Change Order

RHS Culinary Arts Renovation BG 25-203
1103 W 9th Street
Russellville, KY 42276

Change Order Number: 001
Date: the 17th day of June in the year
2025

Re: PR-01– Electrical Panelboards
Russellville Independent Schools Culinary Arts Renovation
CMTA Project No. XRIH24

E1.0

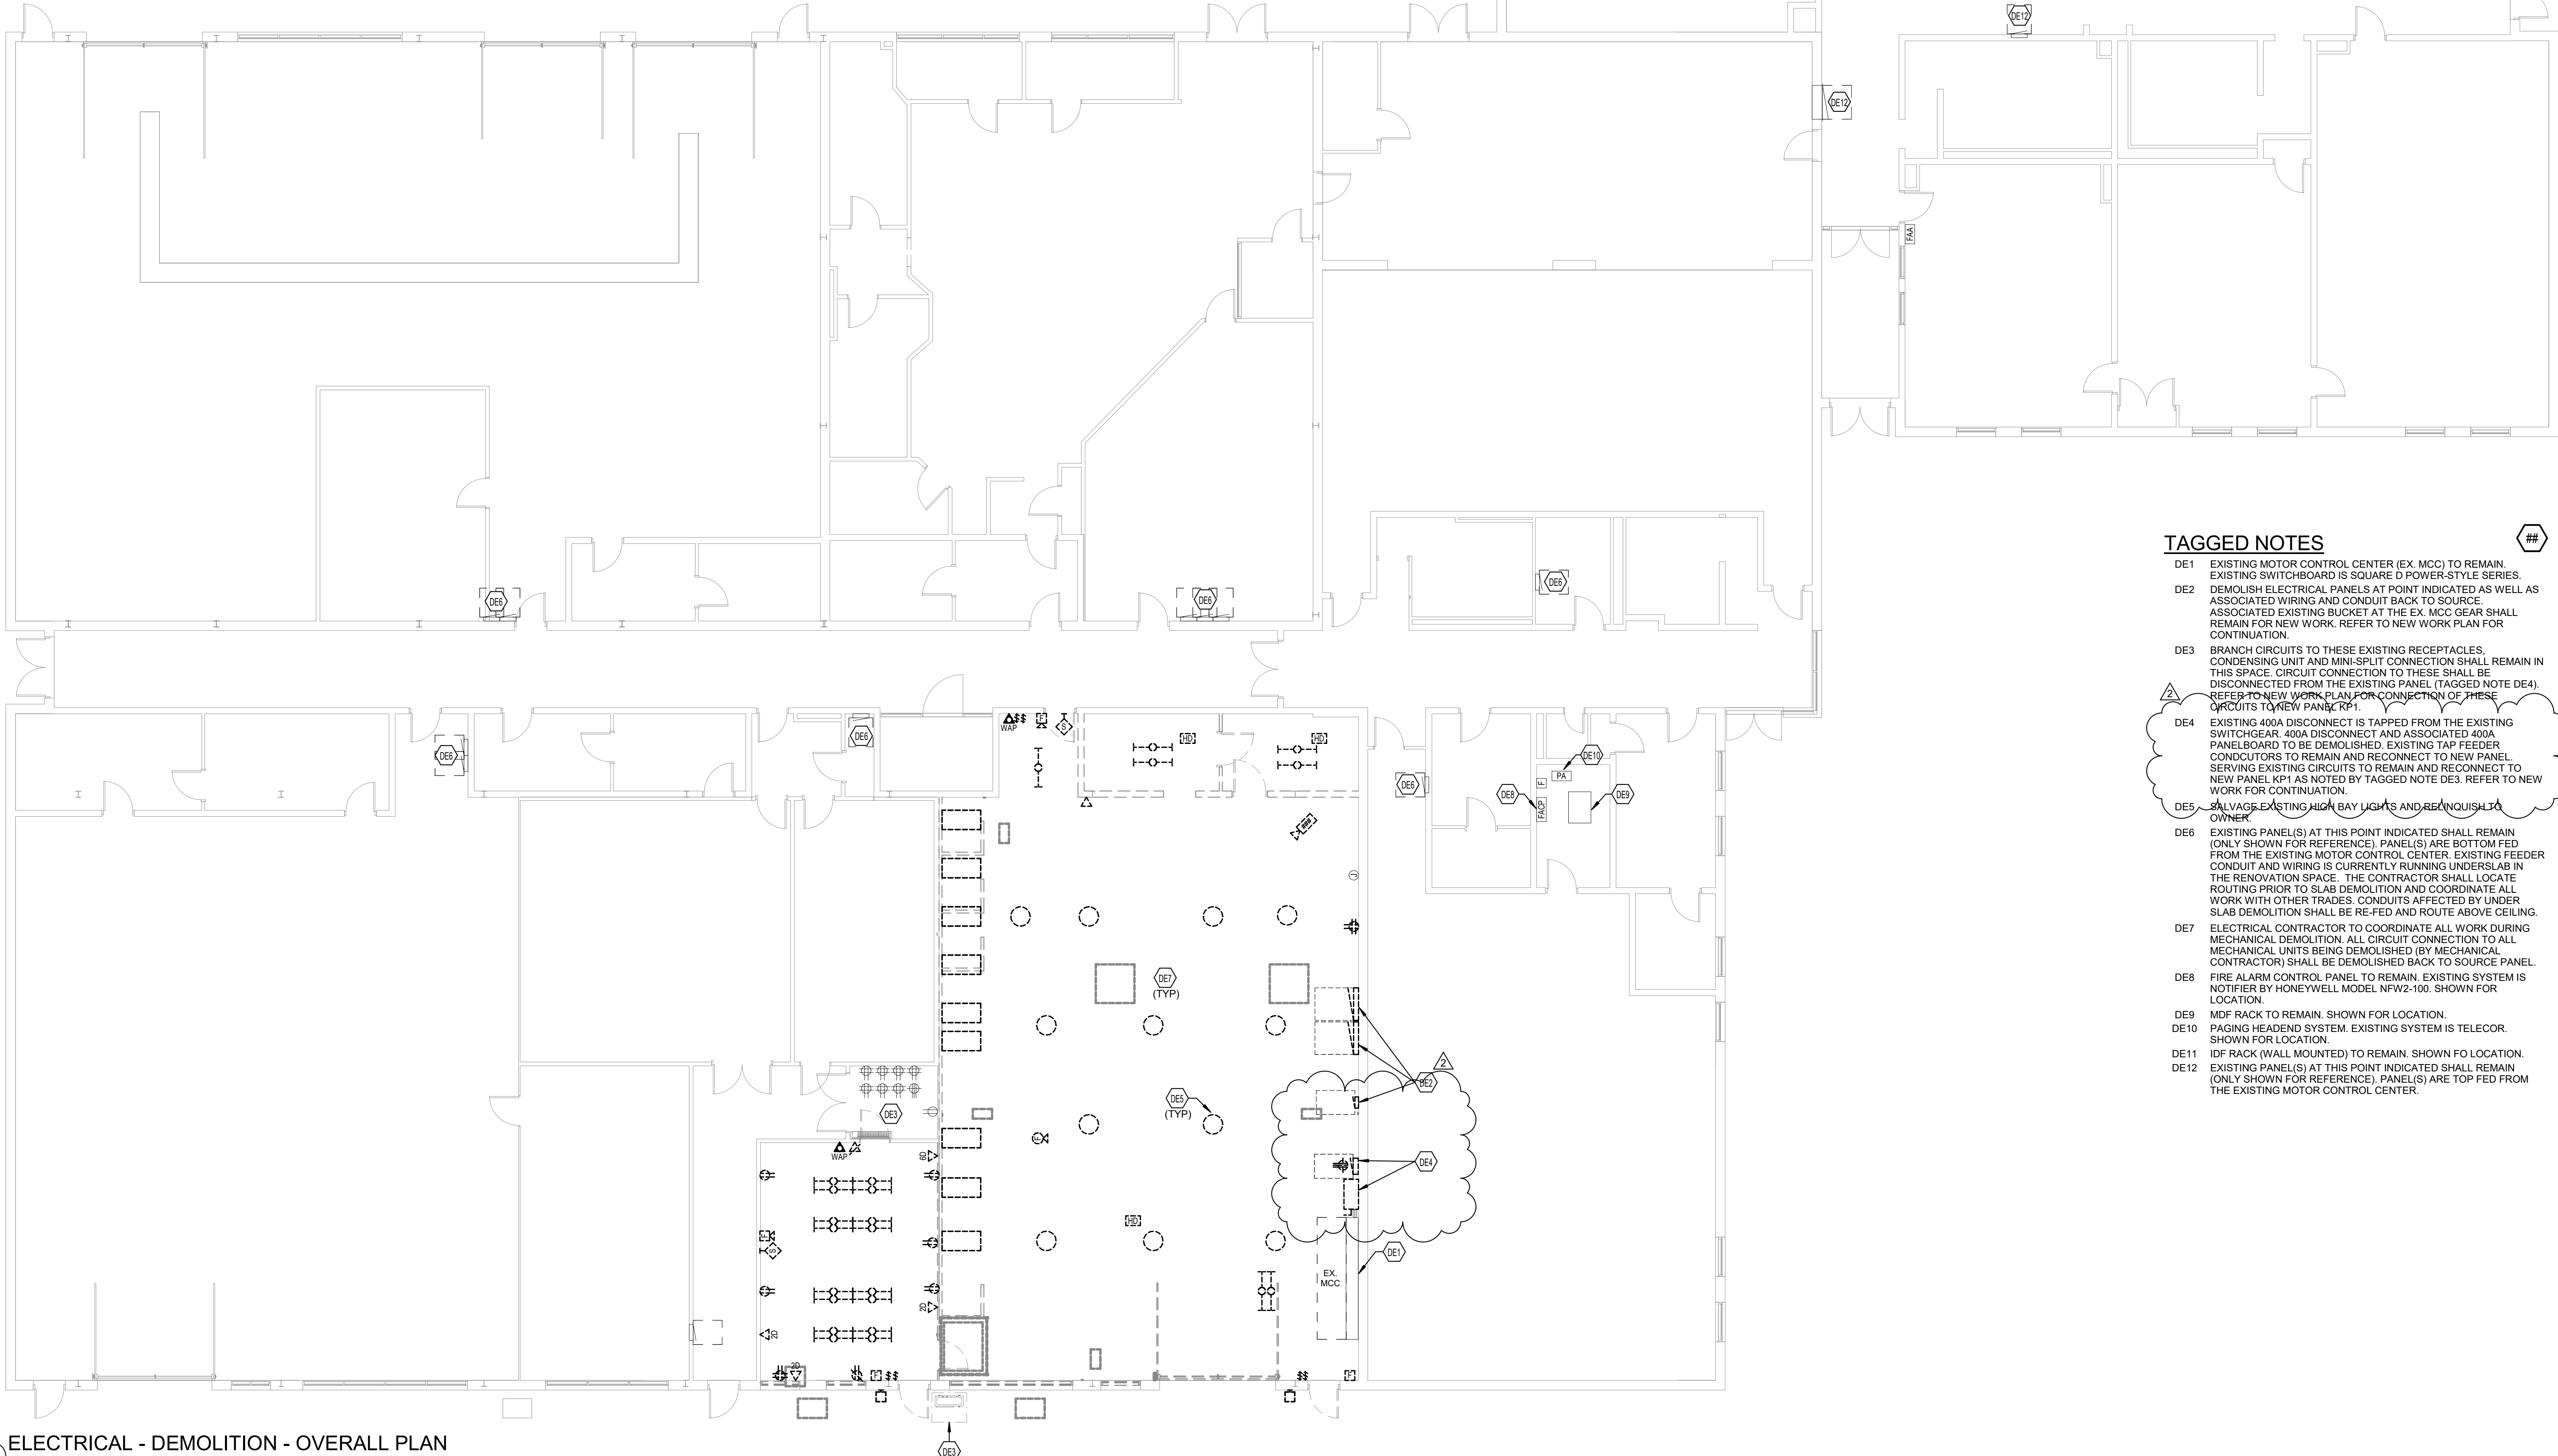
1. Refer to Sheet E1.0 – ELECTRICAL – DEMOLITION – OVERALL PLAN
 - a. Refer to clouded region and clouded notes stating that existing tap feeder conductors shall remain for new MP1 panelboard.

- DE4 EXISTING 400A DISCONNECT IS TAPPED FROM THE EXISTING SWITCHGEAR. 400A DISCONNECT AND ASSOCIATED 400A PANELBOARD TO BE DEMOLISHED. EXISTING TAP FEEDER CONDUCTORS TO REMAIN AND RECONNECT TO NEW PANEL. SERVING EXISTING CIRCUITS TO REMAIN AND RECONNECT TO NEW PANEL KP1 AS NOTED BY TAGGED NOTE DE3. REFER TO NEW WORK FOR CONTINUATION.

E11 EXISTING TAP FEEDER CONDUCTORS FROM EX MCC SHALL TERMINATE AND THE NEW MP1 PANELBOARD

E3.0

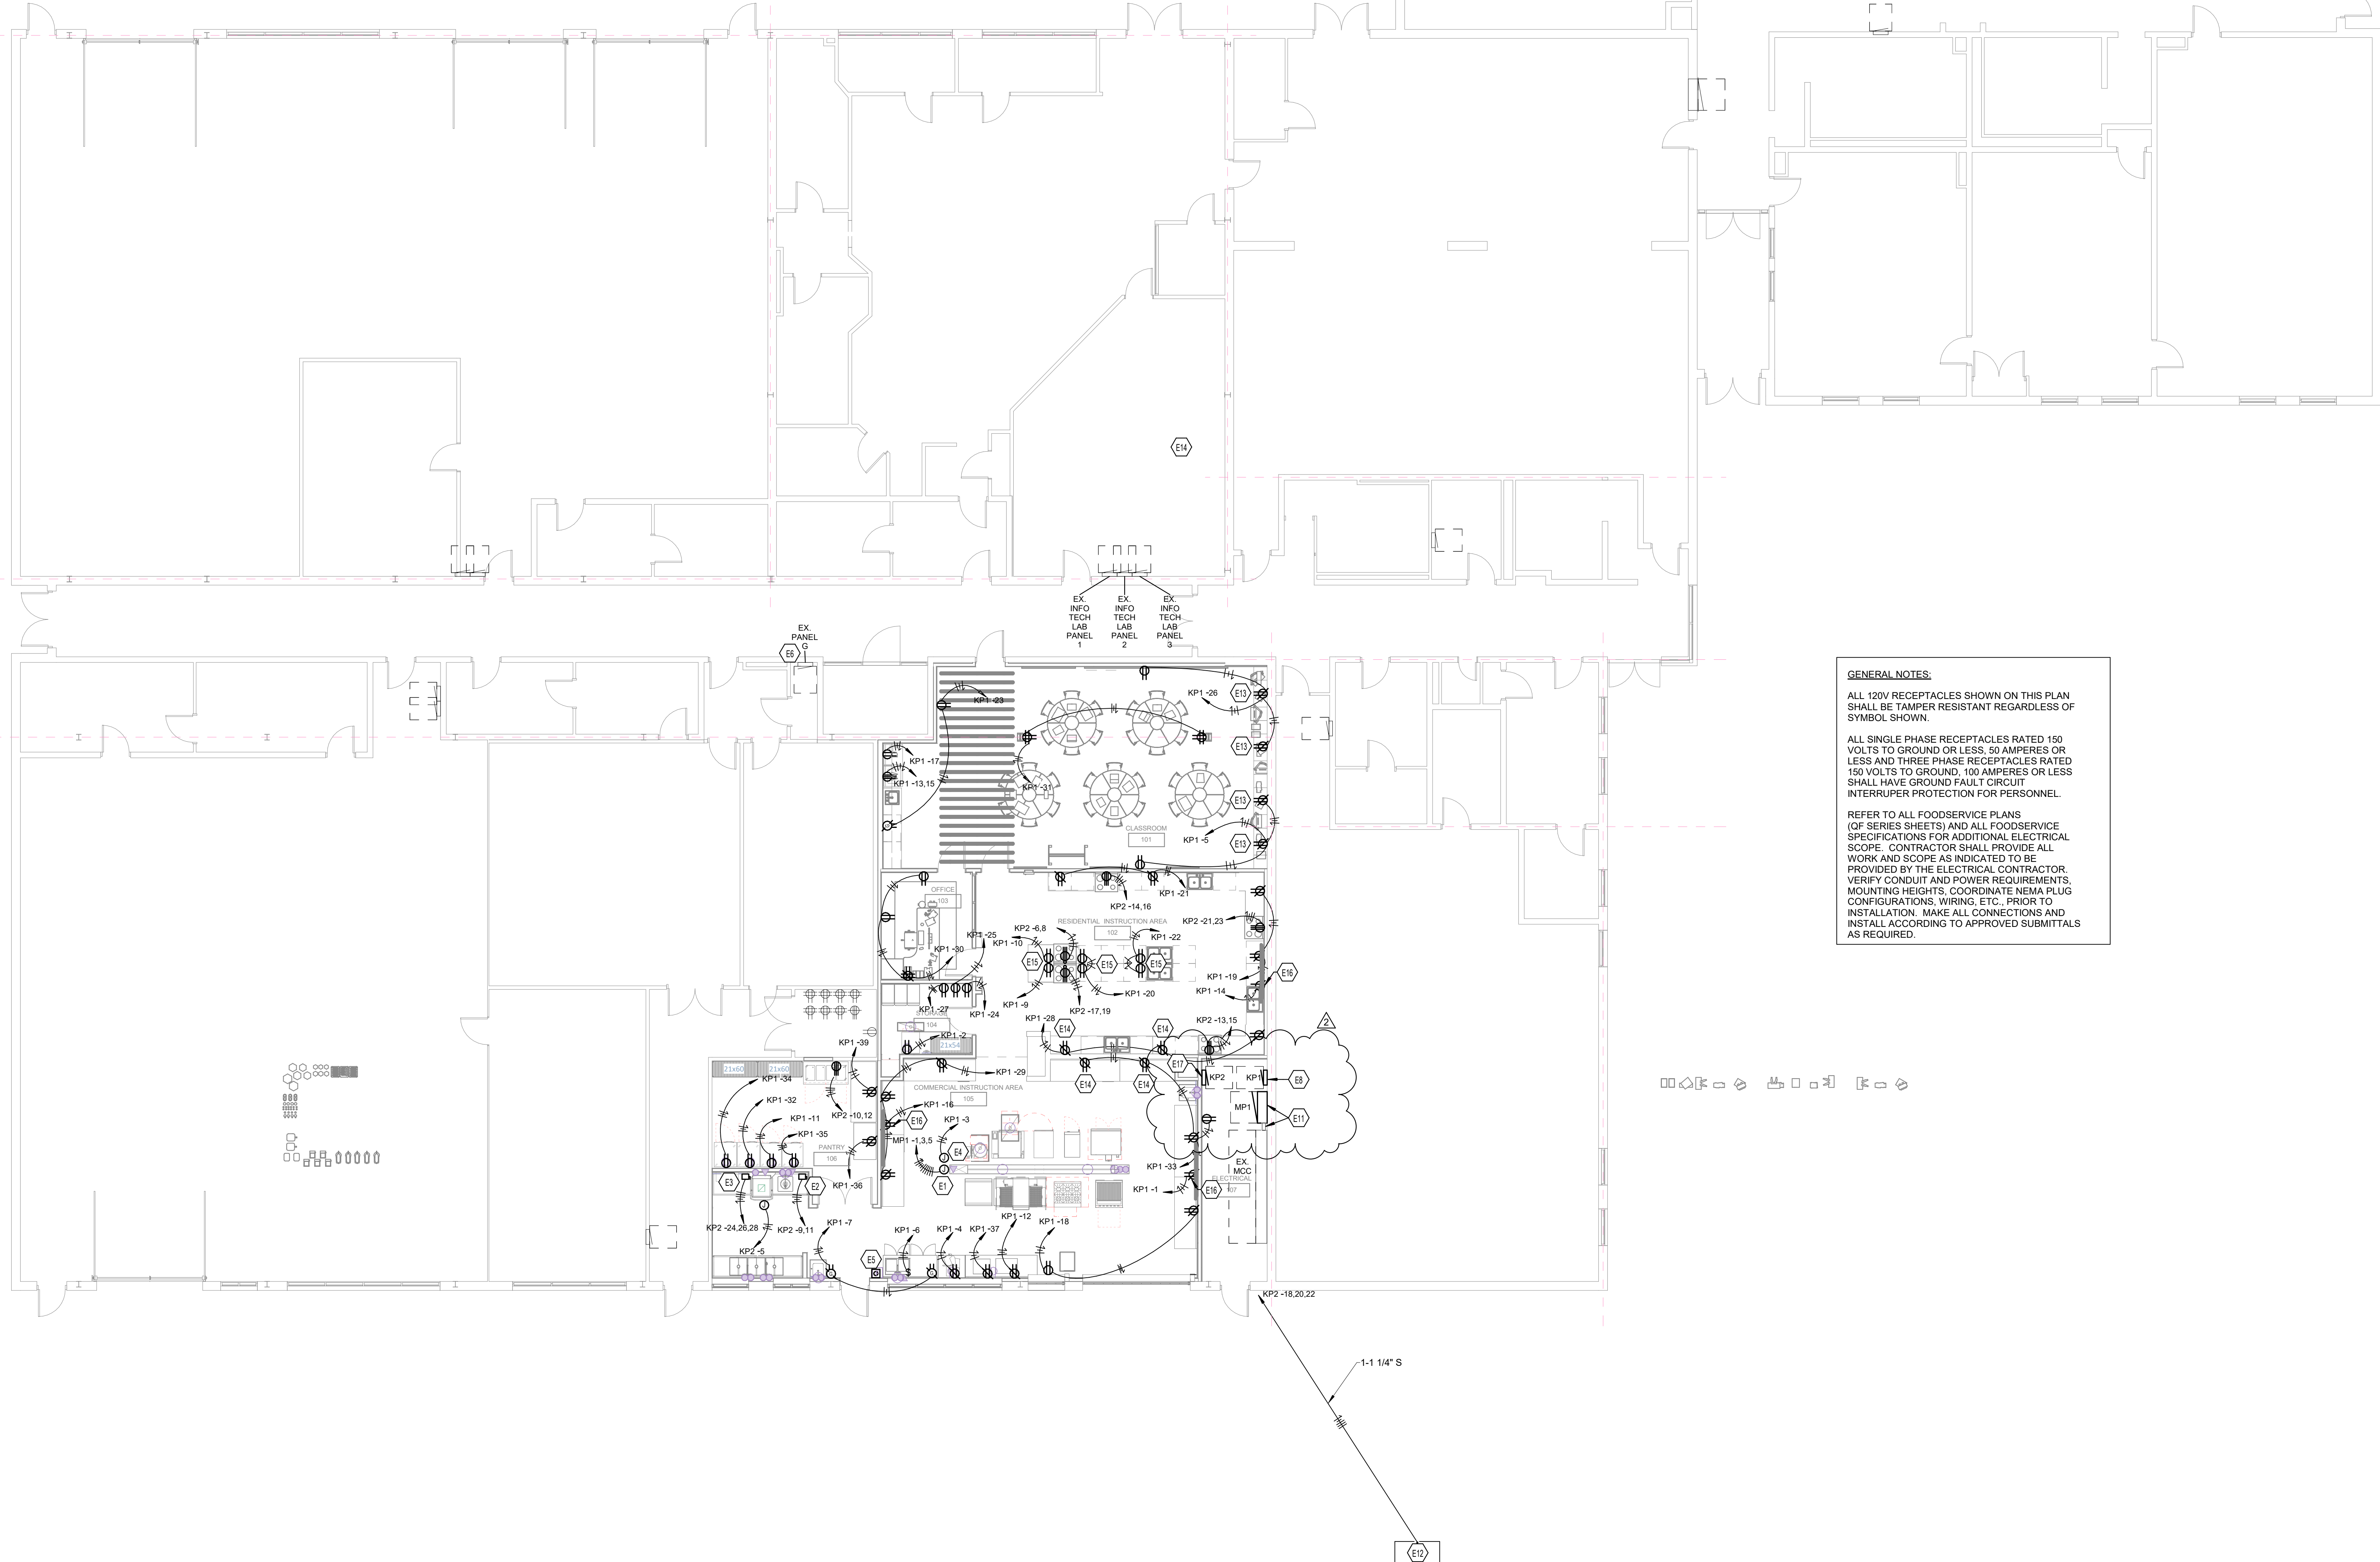
2. Refer to Sheet E3.0 – POWER – NEW WORK – OVERALL PLAN
 - a. Refer to clouded region and clouded notes for provision of power to new panelboards.
 - b. General: Refer to homerun arrows and updated panel-circuit number for each circuit. This issuance shall be used for panel numbering.

E8 UTILIZE EXISTING 200A BUCKET/BREAKER AT THE EX MCC (PREVIOUSLY FEEDING WELDING PANELS E/F) TO FEED NEW KP1 PANELBOARD. PROVIDE 3-#30 PER PHASE, 1-#30 FOR NEUTRAL, AND 1-#6 FOR GROUND IN 2" CONDUIT.

E17 UTILIZE EXISTING 400A BUCKET/BREAKER AT THE EX MCC (PREVIOUSLY FEEDING WELDING TIG SUB PANEL 1) TO FEED KP2 PANELBOARD. PROVIDE 2 RUNS OF 3-#30 PER PHASE, 1-#30 FOR NEUTRAL, AND 1-#3 FOR GROUND EACH RUN IN 2" CONDUIT.
